Access Compliance Report

Public Rights-of-Way

(Curb Ramps)

Intersection ID: 18963	Main Street: GROVER_RD	Cross Street: SOUTH_BV	Location: NE
ADA ID: EE283E48F630	Ramp Type: PerpDiag	Initial Pass/Fail: Fail	Overall Compliance: No
Severity Score: 25			
Codes/Mitigation Info/Possible Solution		Field Measurements/Component Compliance

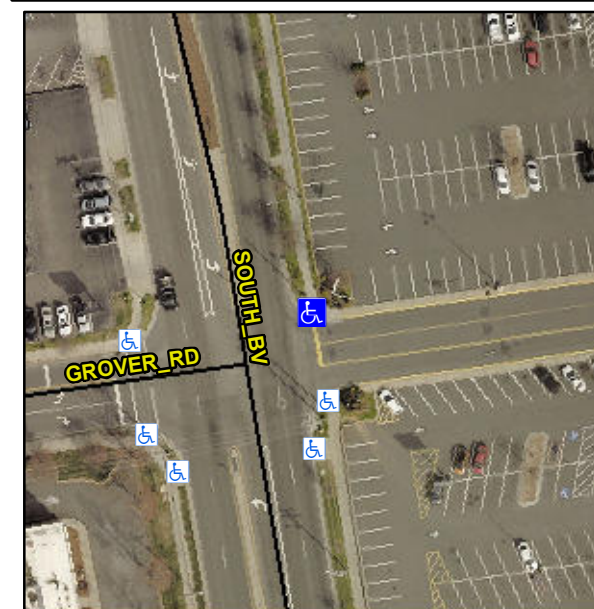
Not Found, R304.5.3

Compliance	Description	Data	Compliance	Description	Data
N/A	Ramp Length (in)	88.0	Yes	Ramp Slope (%)	8.1
Yes	Ramp Width (in)	48.0	No	Ramp XSlope (%)	10.2
N/A	Flare Type LT	N/A	N/A	Flare Type RT	N/A
N/A	Flare Slope LT (%)	N/A	N/A	Flare Slope RT (%)	N/A
N/A	Flare Traversable LT?	N/A	N/A	Flare Traversable RT?	N/A
N/A	Landing Length (in)	N/A	N/A	DWS Provided?	N/A
N/A	Landing Width (in)	N/A	N/A	DWS Contrast?	N/A
N/A	Landing Slope (%)	N/A	N/A	DWS Length (in)	N/A
N/A	Landing X Slope (%)	N/A	N/A	DWS Full Width?	N/A
N/A	Landing Curb? (Y/N)	N/A	N/A	DWS Offset (in)	N/A
N/A	Shared Landing?	N/A			
N/A	Gutter Ponding?	N/A	N/A	Gutter Slope (%)	N/A
N/A	Gutter Lip Ht (in)	N/A	N/A	Gutter X Slope (%)	N/A
N/A	Painted X Walk1?	No	N/A	Painted X Walk2?	No
	X Walk 1 Direction	To W		X Walk 2 Direction	To S
N/A	X Walk 1 Width (in)	N/A	N/A	X Walk 2 Width (in)	N/A
	X Walk 1 Slope (%)	1.4		X Walk 2 Slope (%)	0.5
	X Walk 1 X Slope (%)	2.7		X Walk 2 X Slope (%)	4.1

Remove & Replace Curb Ramp With Two New Directional Ramps or Equivalent.
